**MONTGOMERY COUNTY HISTORIC PRESERVATION COMMISSION**  
**STAFF REPORT**

<b>Address:</b>	7211 MacArthur Blvd., Bethesda	<b>Meeting Date:</b>	2/11/2026
<b>Resource:</b>	Contributing Resource <b>Potomac Overlook Historic District</b>	<b>Report Date:</b>	2/4/2026
<b>Applicant:</b>	Jeong Kim	<b>Public Notice:</b>	1/28/2026
<b>Review:</b>	HAWP	<b>Staff:</b>	Dan Bruechert
<b>Permit No.:</b>	1126423 REVISION	<b>Tax Credit:</b>	Partial
<b>Proposal:</b>	Door Replacement

The applicant proposes to remove and replace an existing door.

EXISTING NORTH ELEVATION

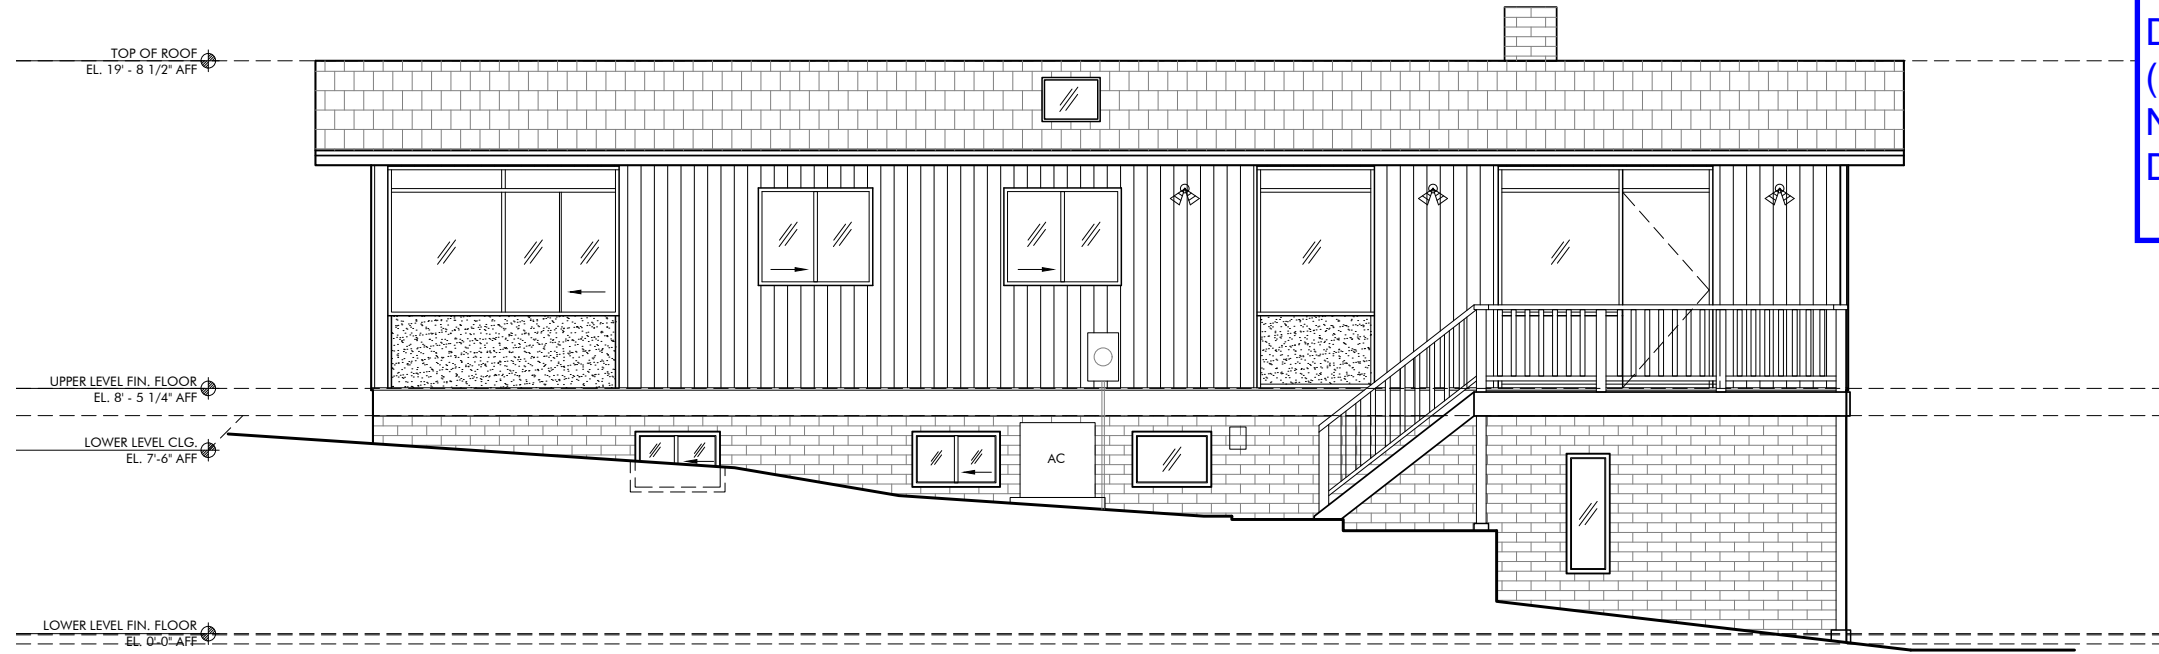
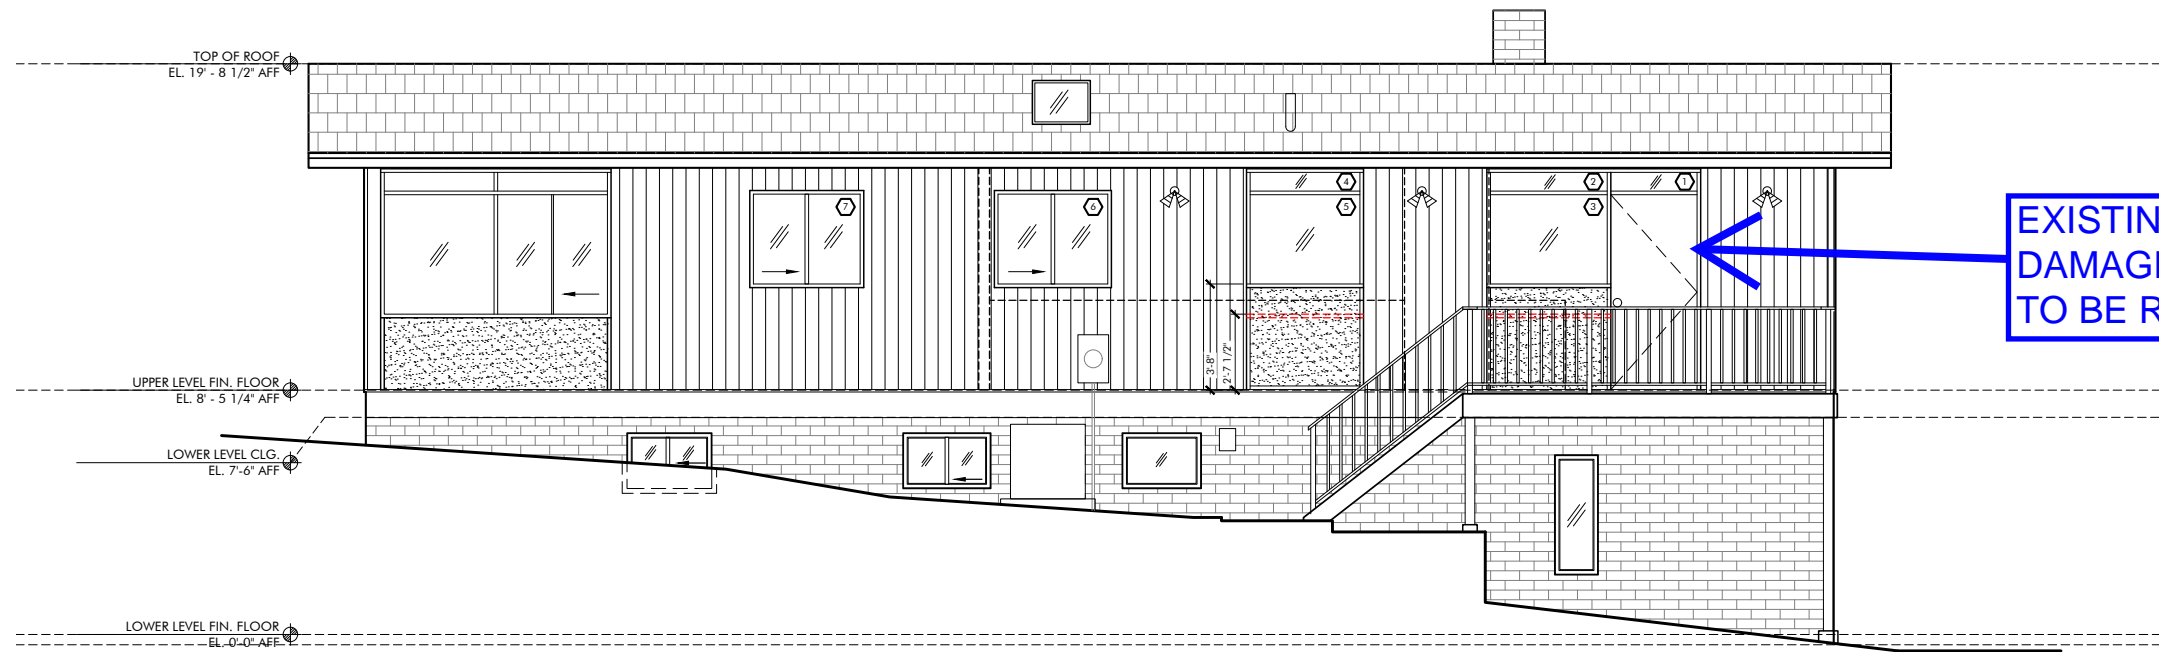
EXISTING  
DAMAGED DOOR  
TO BE REPLACED
